AGENDA
PLANNING AND ZONING COMMISSION MEETING
CITY OF CREVE COEUR, MISSOURI
MONDAY, DECEMBER 21, 2015
6:00 PM

1. **Application #14-022: Revised Site Development Plan Approval at the Shoppes at Westgate**

**APPLICATION TO PLANNING AND ZONING COMMISSION
#14-022 FOR REVISED SITE DEVELOPMENT PLAN APPROVAL
AT THE SHOPPES AT WESTGATE**

The Shoppes at Westgate

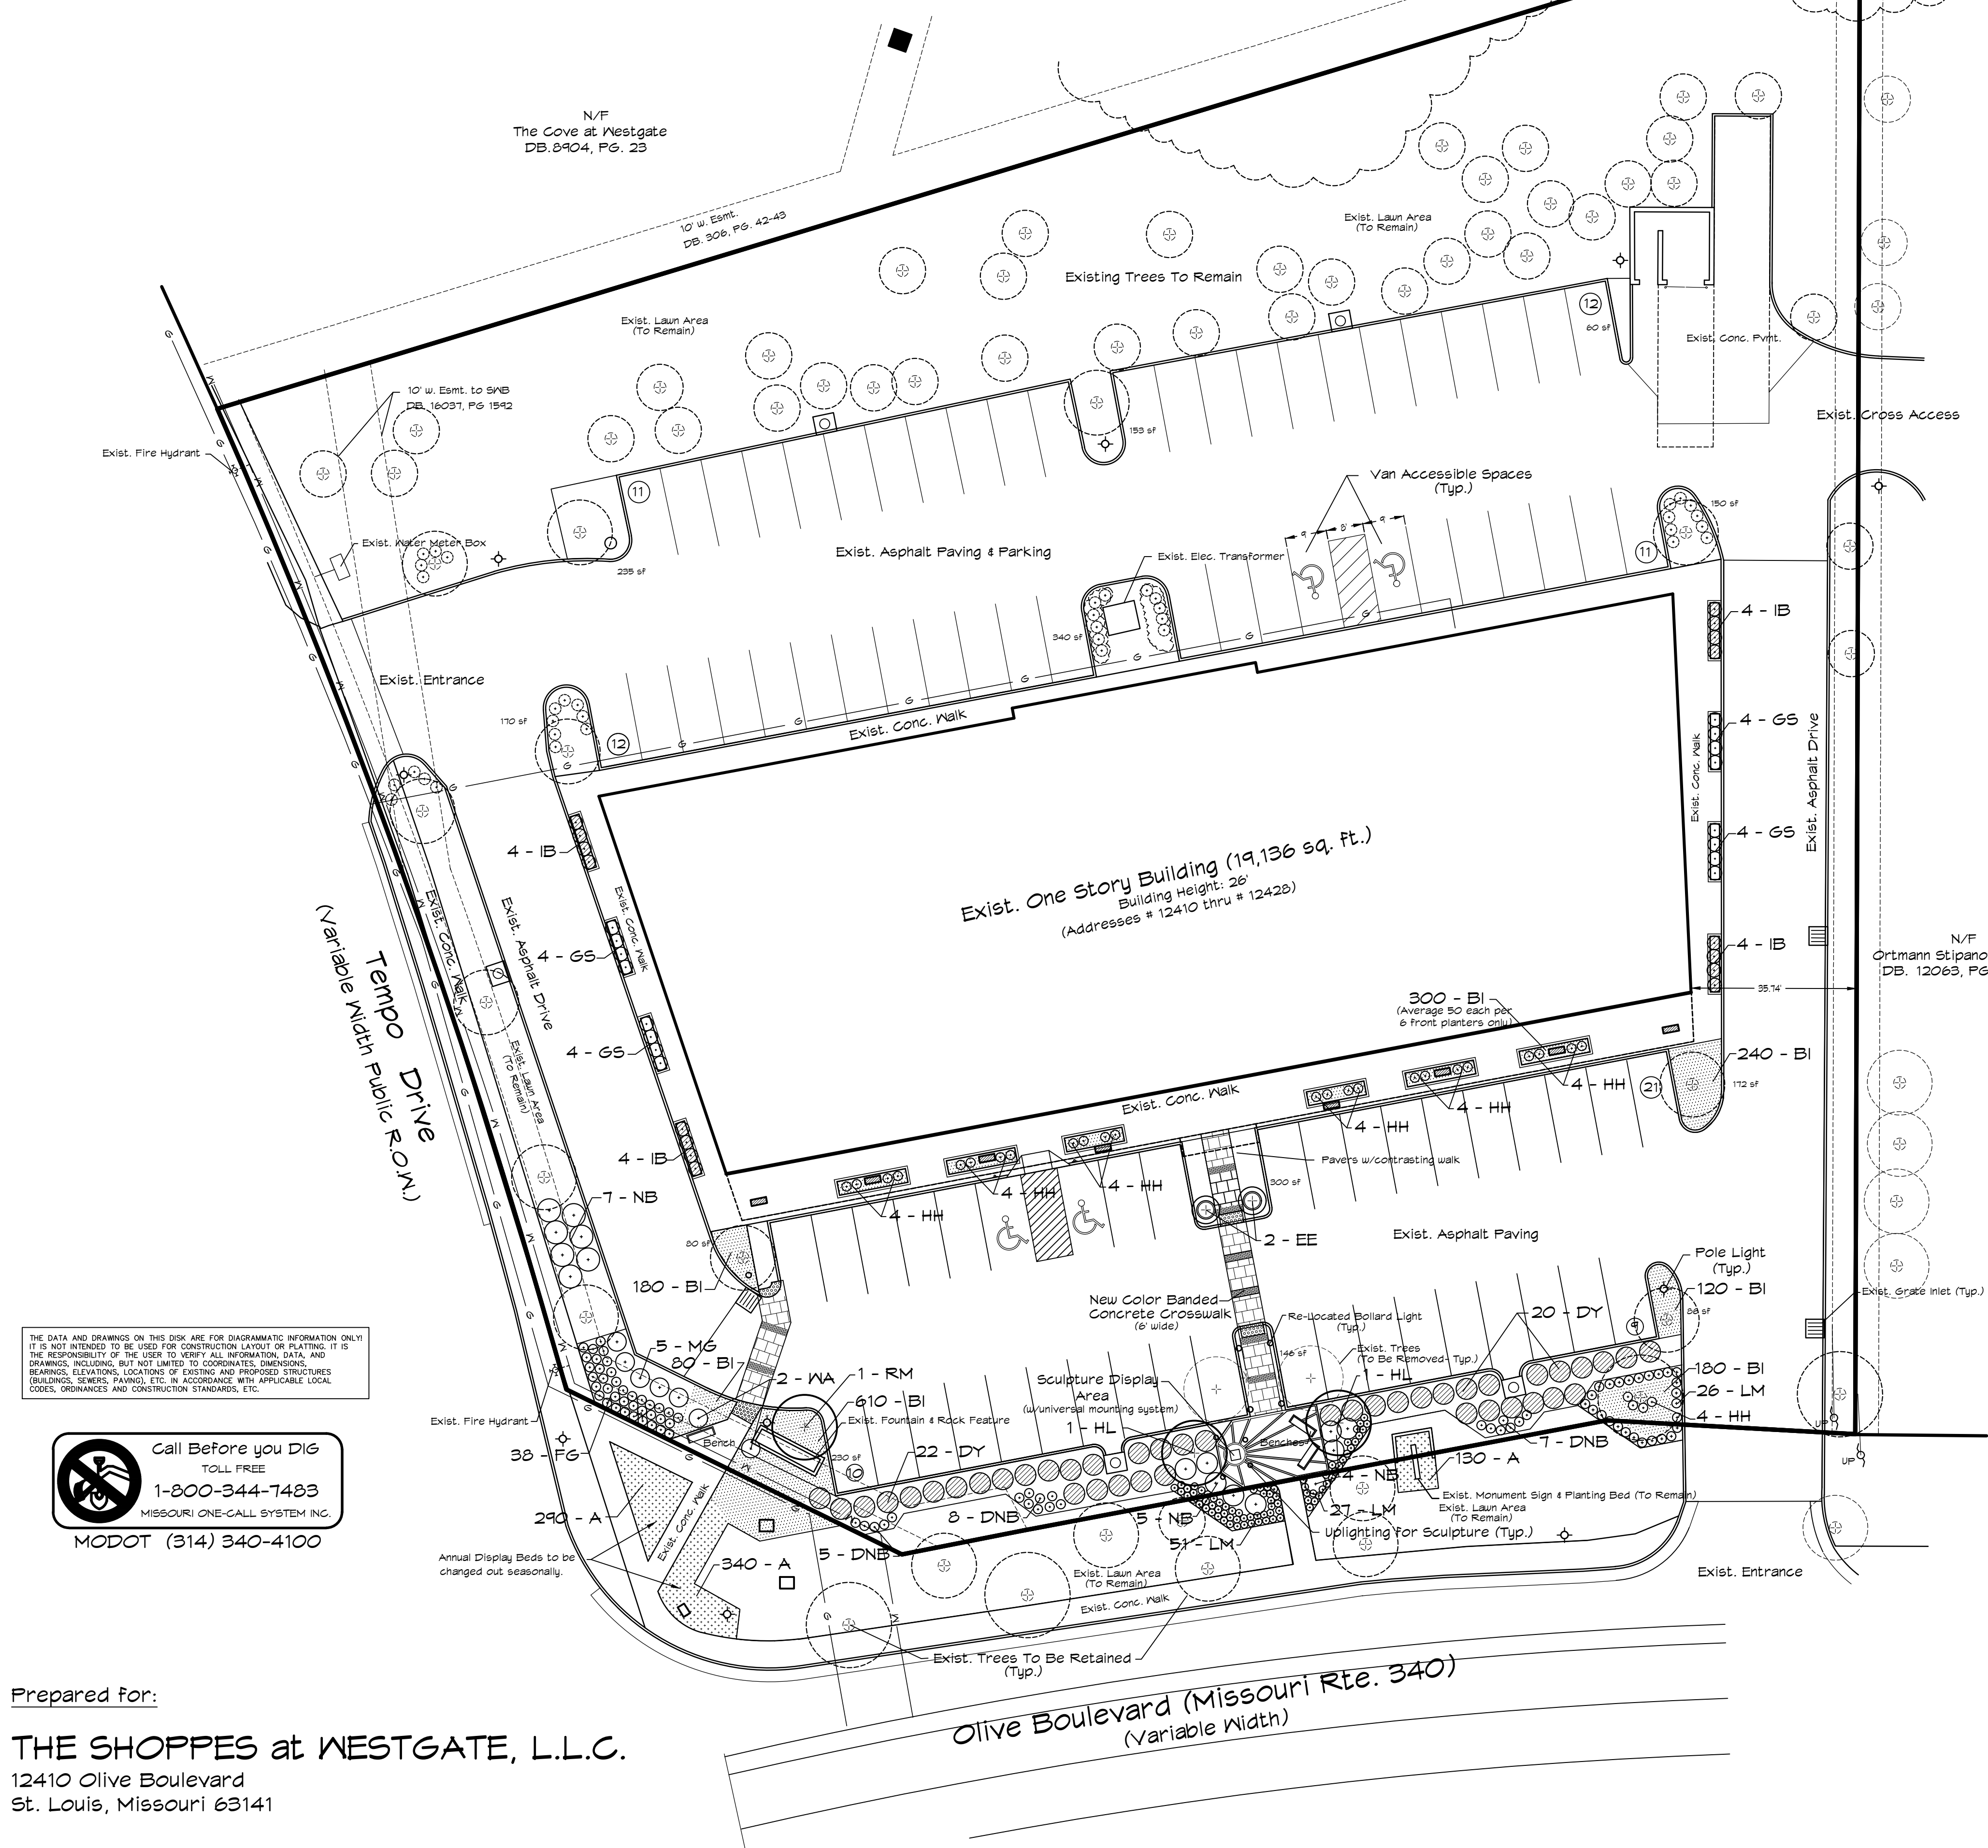
As discussed in the prior staff report, the inclusion of the artwork display area and loan program provides for a unique option and is supported by the Arts Committee. Staff is in agreement with the removal of the greenspace for the creation of the two new parking spaces at the corner and the narrowing of the walkway at the center for the two new parking spaces as shown in Figure 6. Staff still finds that the proposed changes to the front of the building represents a loss in design quality and has offered suggestions for consideration. In addition, Staff favors leaving the patio area adjacent to the building in its current condition for the reasons discussed previously.

NORTH ELEVATION - EXISTING

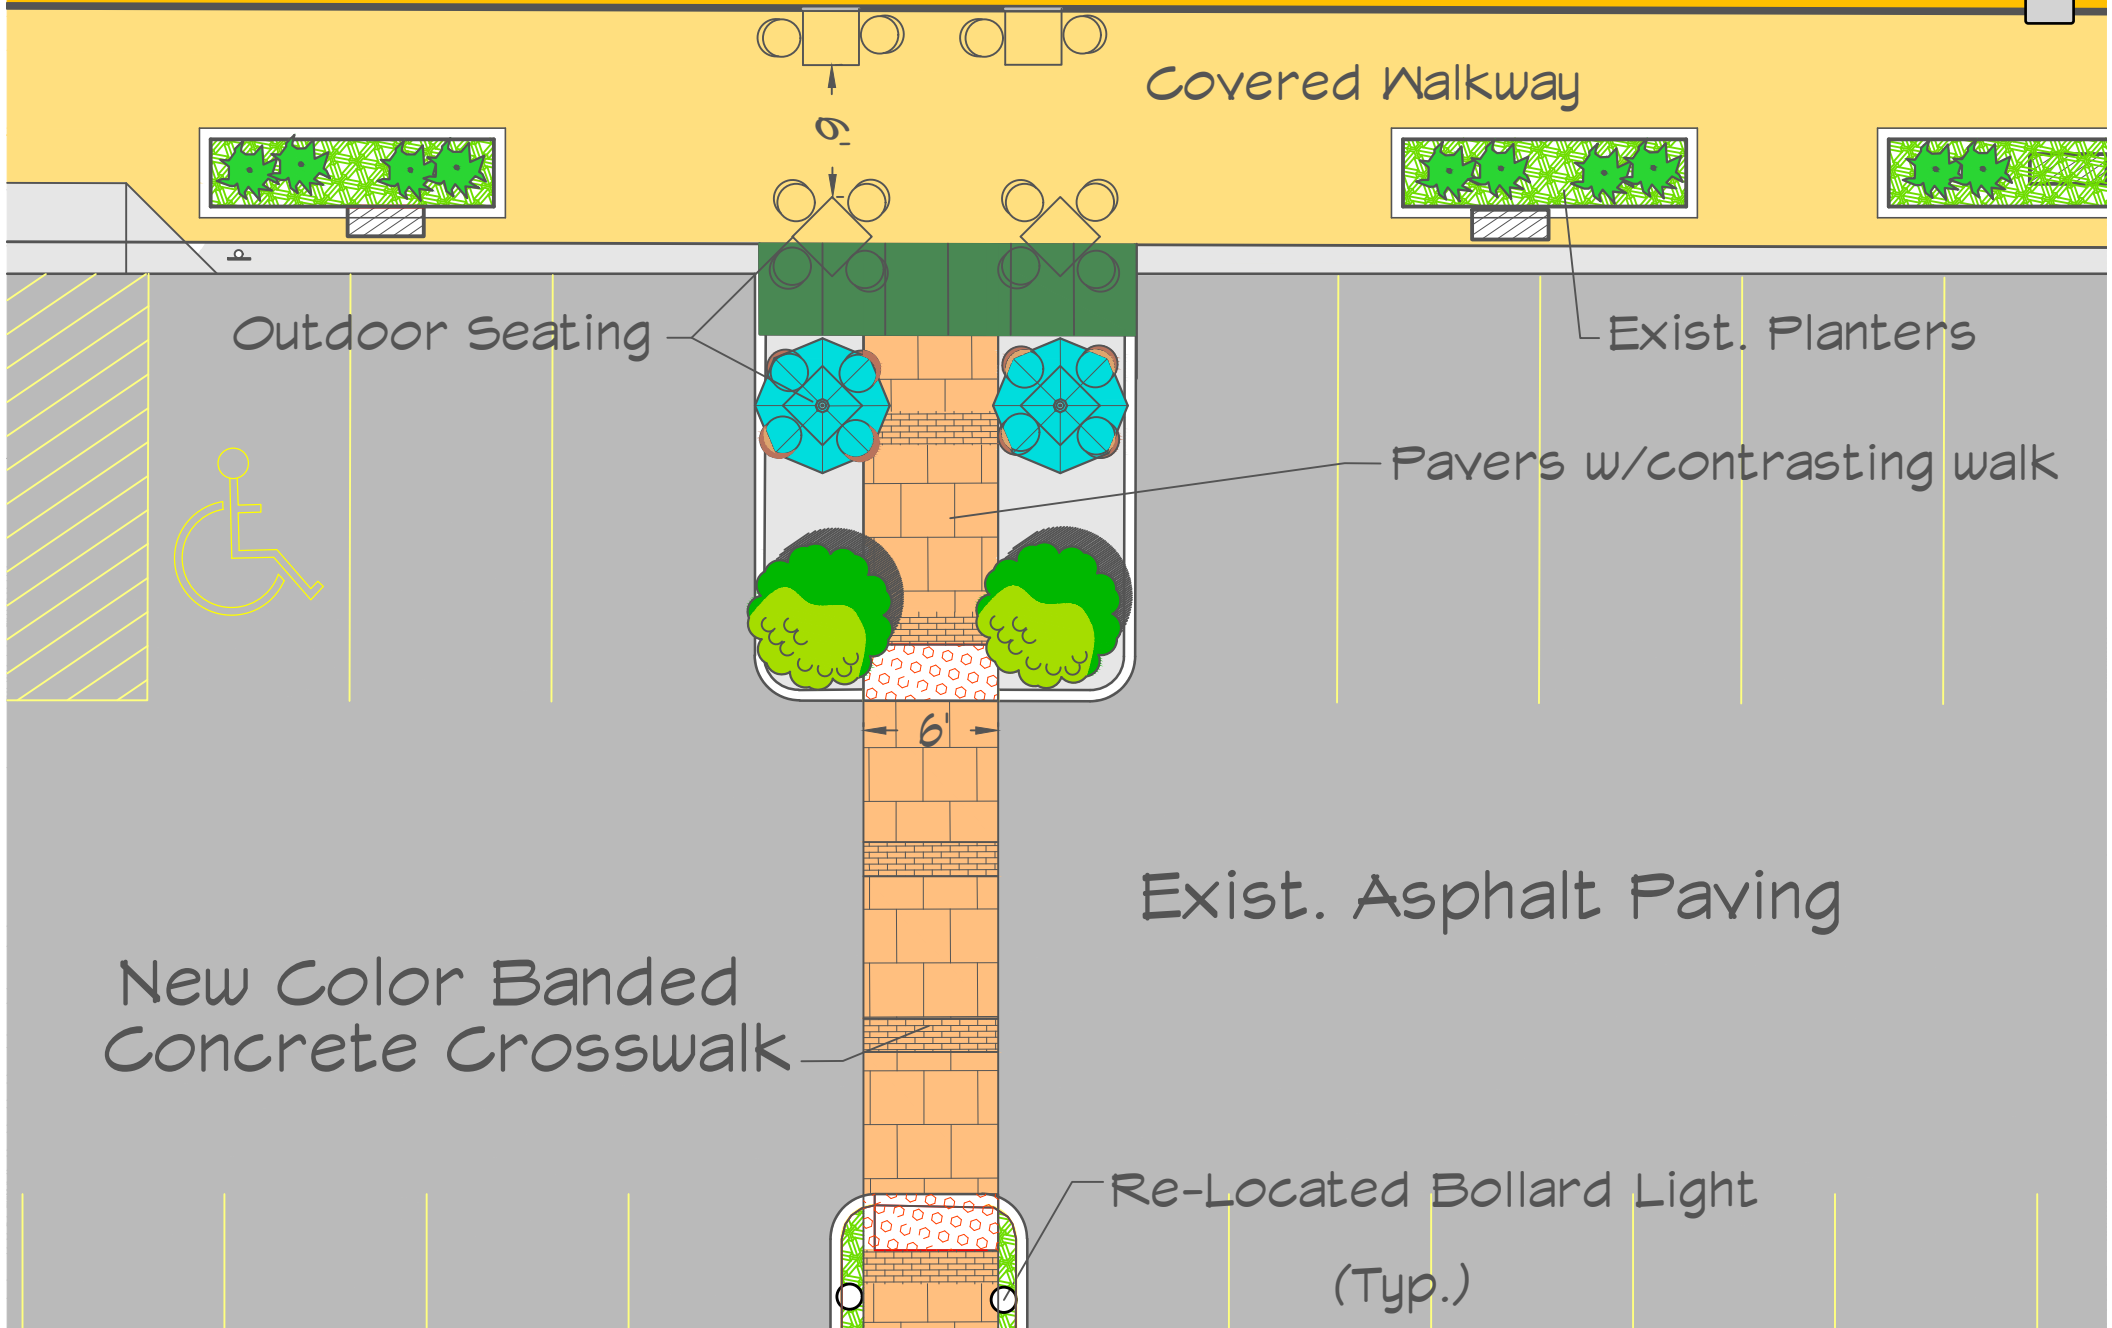
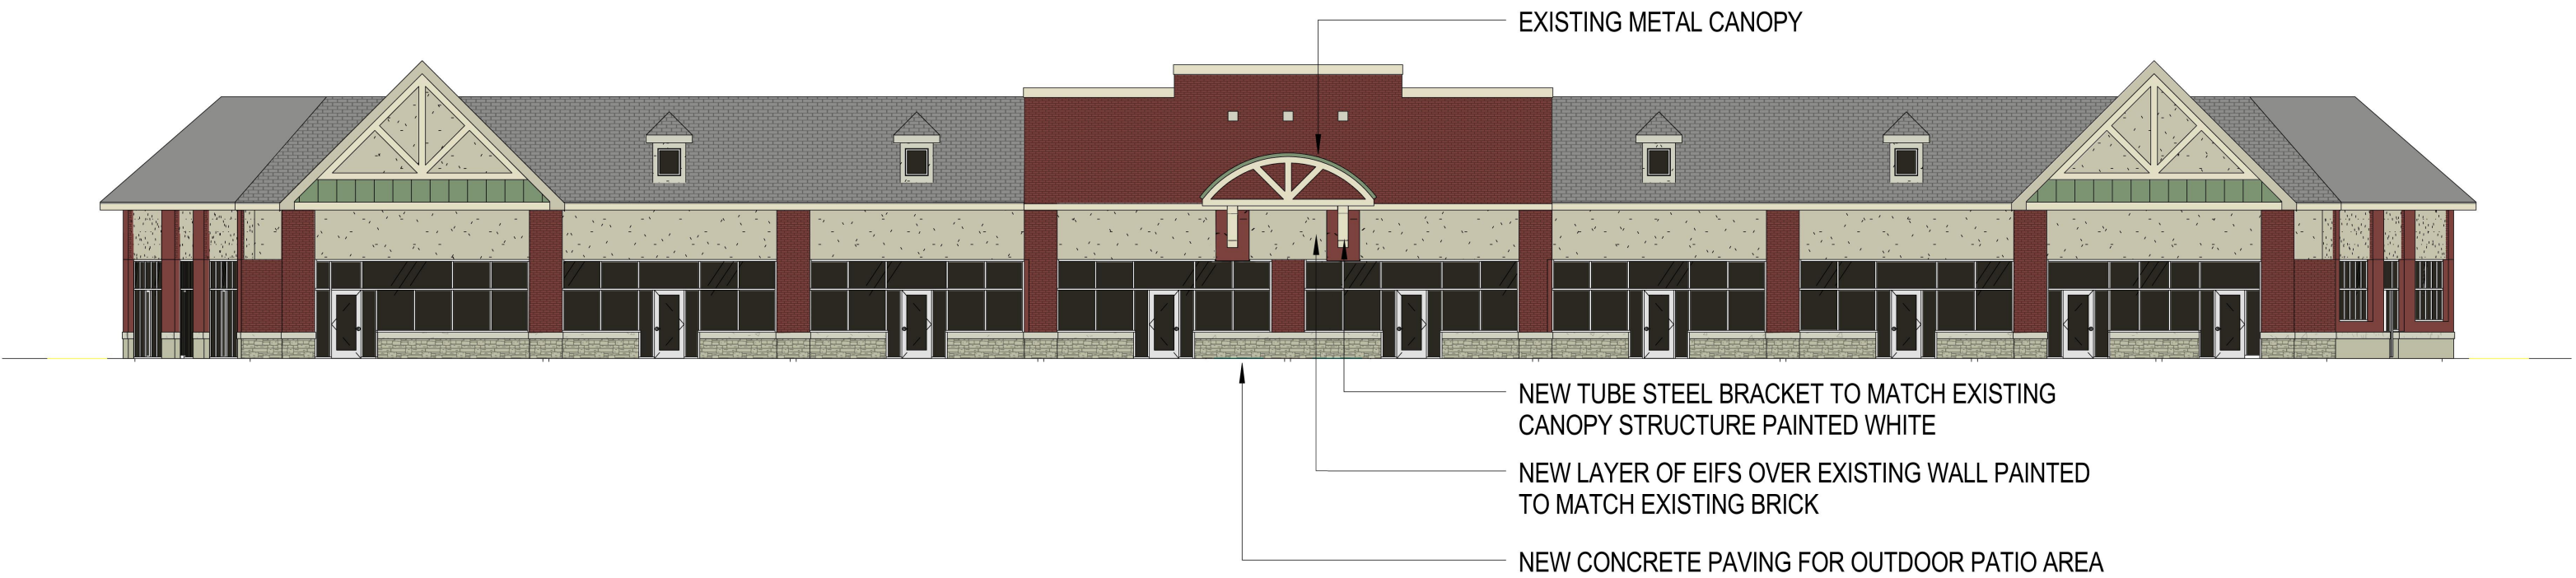
Figure 1: Revised north elevations

As discussed in the prior staff report the narrowing of the outdoor plaza area does not provide enough room for adequate seating as there is only four feet on either side of the new sidewalk. In addition, the opening and closing of doors would prevent any available room for outdoor furniture as shown in Figure 2. While the other areas discussed below may be viewed as a shifting of the elements to allow for the additional site coverage, this area represents a reduction in the amenities and movement further away from the recommendations of the Design Guidelines and Comprehensive Plan that are part of a review for any project, and a step back when part of a consideration for a site coverage bonus. Therefore, Staff maintains the recommendation that the existing plaza adjacent to the building should remain, while the existing planter should be removed to allow for greater pedestrian activity and outdoor dining space.
